**ADDRESS: 29 N 2ND ST**

Proposal: Construct rooftop addition, replace windows, rebuild storefront

Review Requested: Final Approval

**STAFF RECOMMENDATION:** Denial, pursuant to Standard 9 and the Storefronts Guideline.

Proposed Facade Rendering

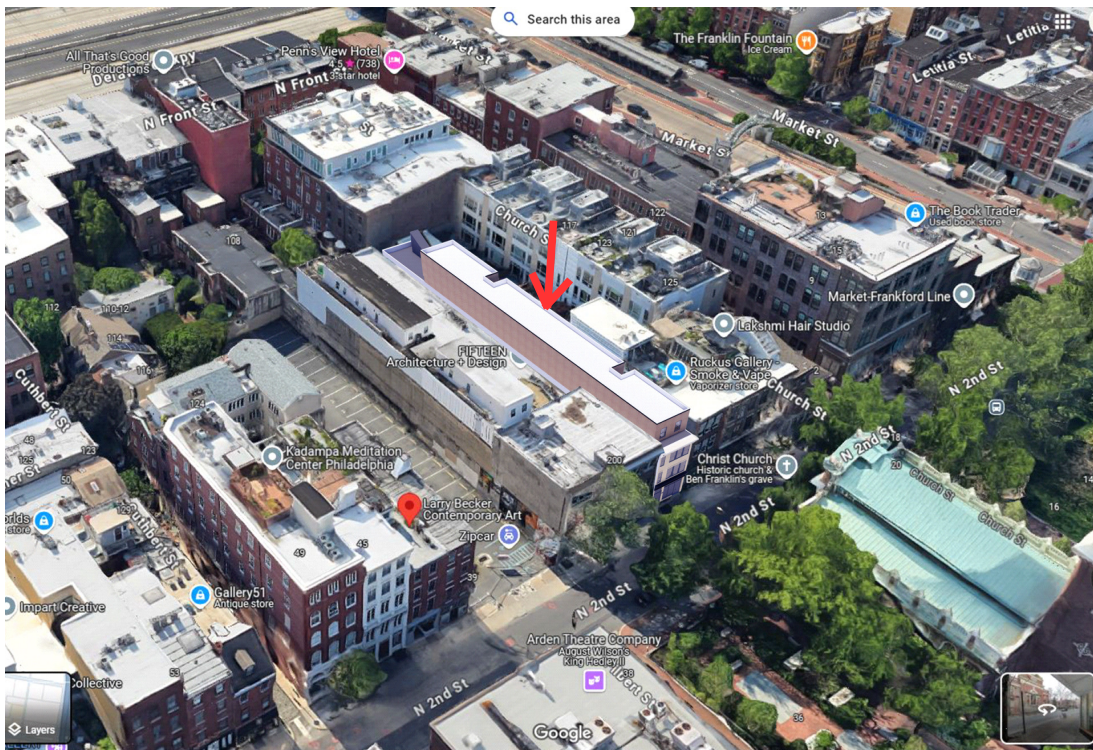
- The rooftop addition would be conspicuously visible from the public right-of-way. Shifting the addition farther from the historic façade may limit its impact on the property's character-defining features.

- Few details are provided for the siding proposed for the addition, and it is not clear that it is an appropriate material for this context.
- **Storefronts Guideline:** *Identifying, retaining, and preserving storefronts and their functional and decorative features that are important in defining the overall historic character of the building. The storefront materials (including wood, masonry, metals, ceramic tile, clear glass, and pigmented structural glass) and the configuration of the storefront are significant, as are features, such as display windows, base panels, bulkheads, signs, doors, transoms, kick plates, corner posts, piers, and entablatures.*

1	FRONT ELEVATION - H
H	3/16" = 1'-0"

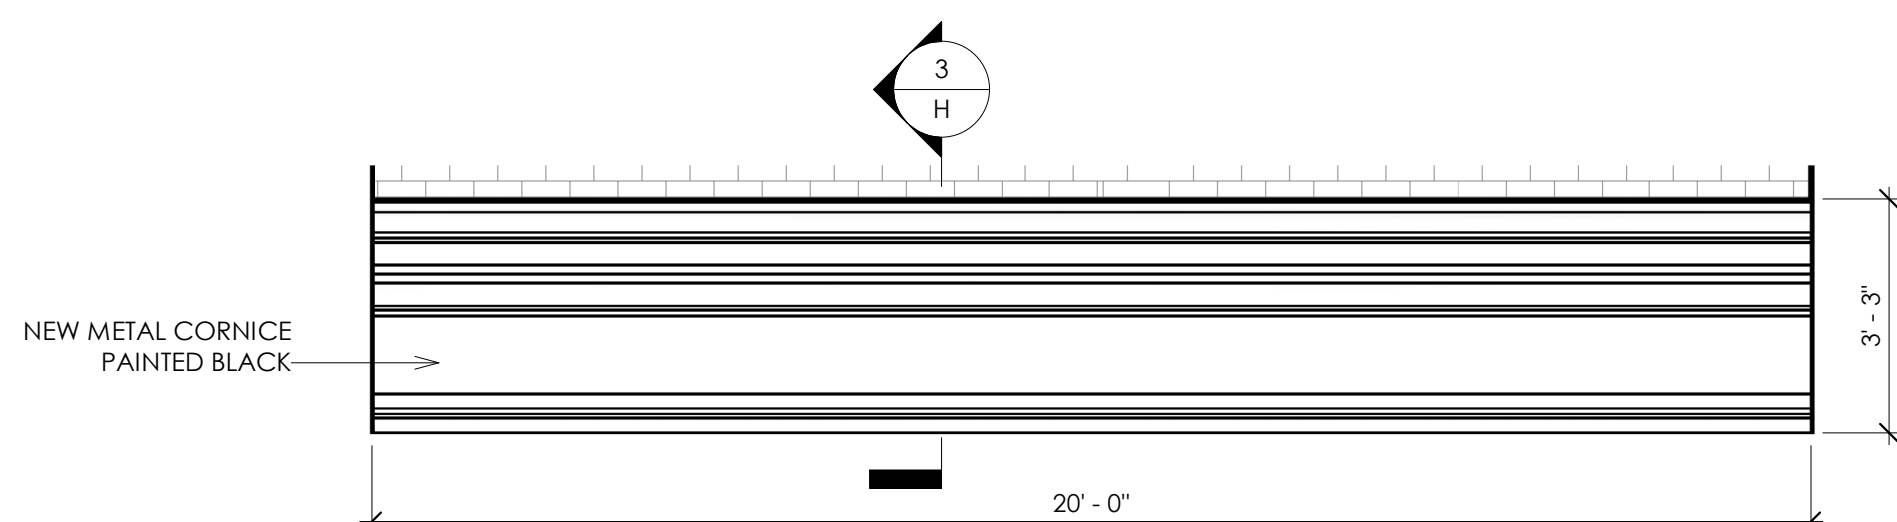
- Further investigation should be undertaken to understand what material from the original storefront may survive behind the current cladding and which could be incorporated into the new storefront.

- Investigation of the fabric behind the current cladding may provide more clarity about the dimensions and materials of the historic storefront beyond what can be vaguely determined from historic photos.
- The cornice should incorporate end brackets, clearly shown in the 1929 photo (below) and shown on other cornices on this block.
- Drawing on historic photographs of other storefronts in the area may yield a more historical design. For instance, the proposed sidelights by the doors do not appear to have precedent on this block, where paired doors are common. A contrasting material below the store window may also be more appropriate.
